Delegated Report

Lawful Development Certificate (Proposed)

Application no:	20231159
Location	94 Dene Holm Road Northfleet Gravesend Kent
Proposal:	Application for a Proposed Lawful Development Certificate in respect of a loft conversion with rear dormer and rooflights to front elevation; single storey rear extension and front porch.
Applicant:	Mr J Preet
Site Visit	N/A Desktop Assessment

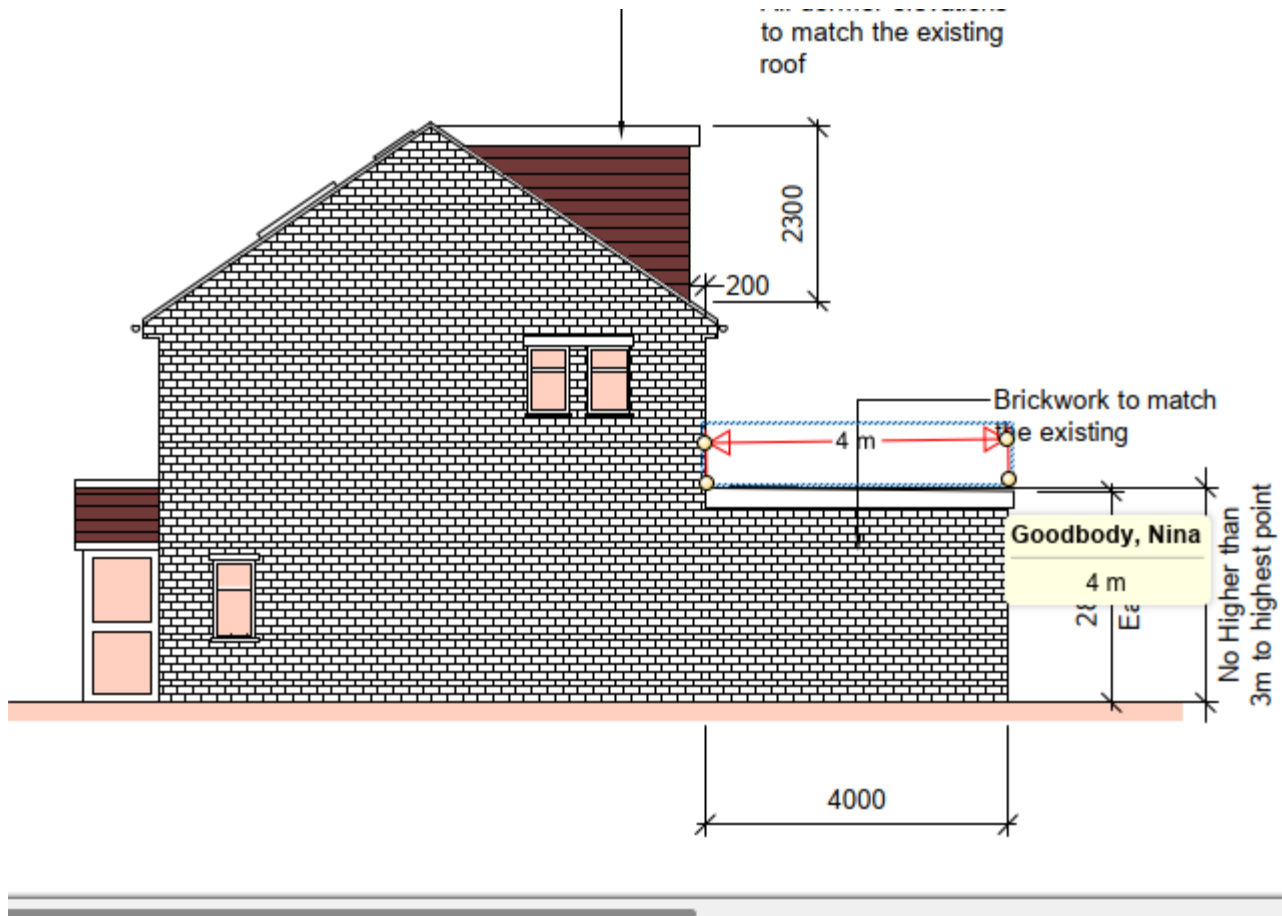
As show below, the proposed extension would exceed the depth limit of 3.00m as set out by A.1(f)(i) for a semi-detached property:

The proposed extension would exceed 3.00m in depth contrary to the requirements of Class A.1 (f)(i).
